Potential Issues with the D1.0 Class Table

Andy Gardner

Linear Technology Corporation

12V Automotive Battery Cold Crank Requirements

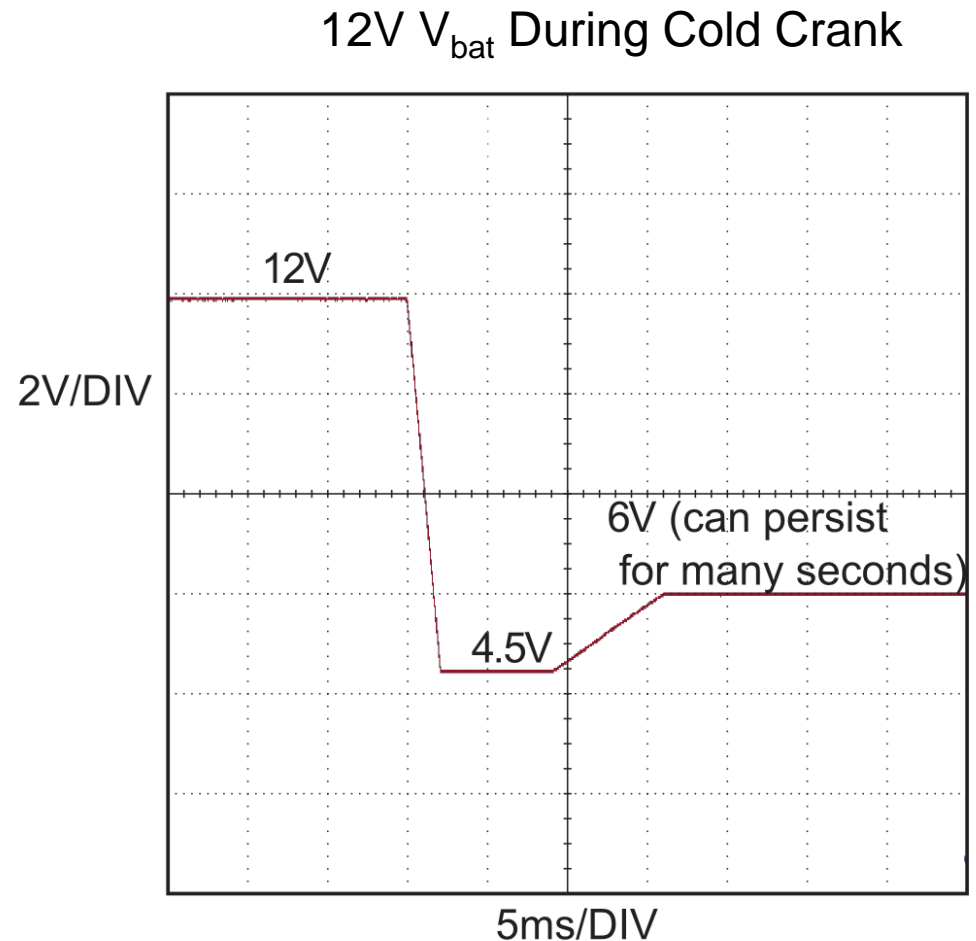
- Normal operation may be required during cold crank.
- The initial dip to 4.5V can be tolerated if enough charge storage is available.
- 6V can last for up to 20 seconds, hence the requirement to operate at 6V indefinitely.

Series Resistance Limits PoDL from a 12V Battery V_{PSE} during Cold Crank

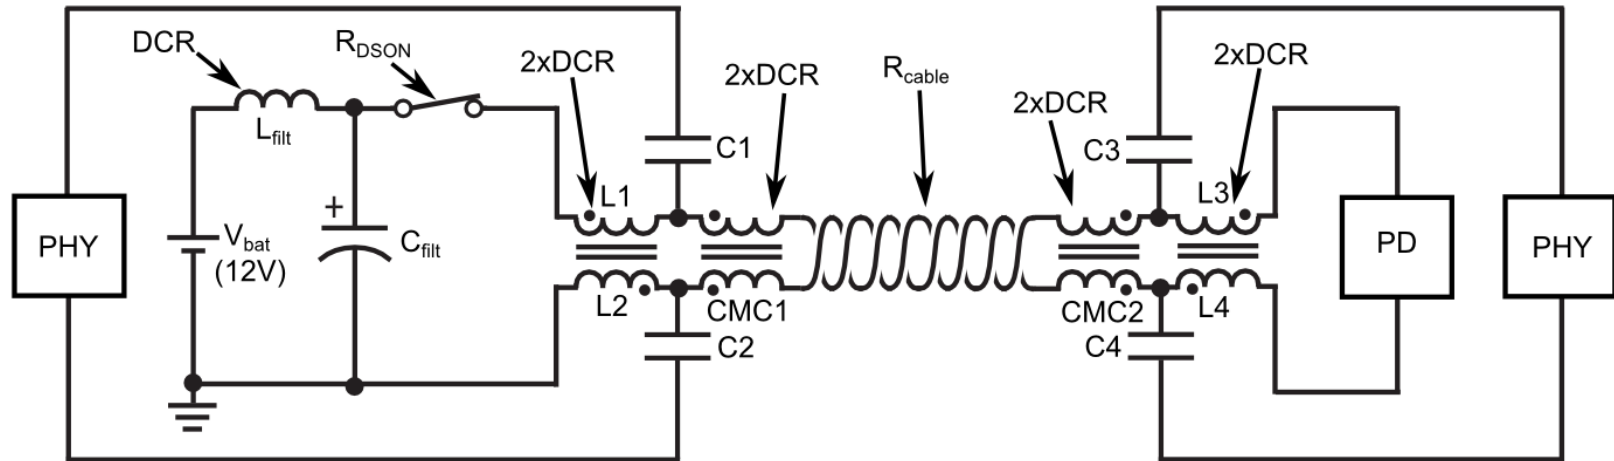
- Series resistance from magnetics DCRs, MOSFET on-resistance(s), and wire resistance must be limited in order to deliver the required power...
- ...but when designing for cold crank, the benefit of adding a boost converter between the battery and the PSE should also be considered.

R_{loop} , R_{PSE} , & R_{cable} in the D1.0 Class Table

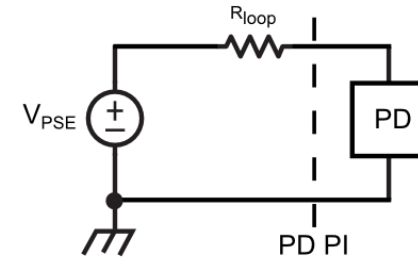
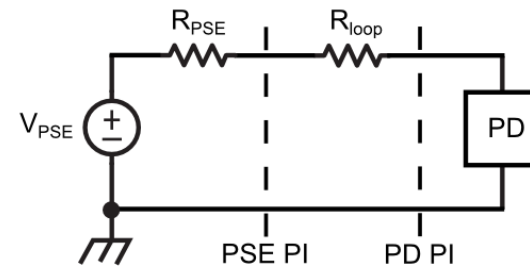
- R_{loop} in the D1.0 class table is defined as the sum of R_{PSE} and R_{cable} .
- Setting $R_{loop} = R_{cable}$ is desirable for non-engineered systems.
- But $R_{cable(max)}$ will be reduced by $R_{PSE(max)}$.
- What is a reasonable value for $R_{PSE(max)}$?

a) Existing class table R_{loop} definition

b) Alternative R_{loop} definition
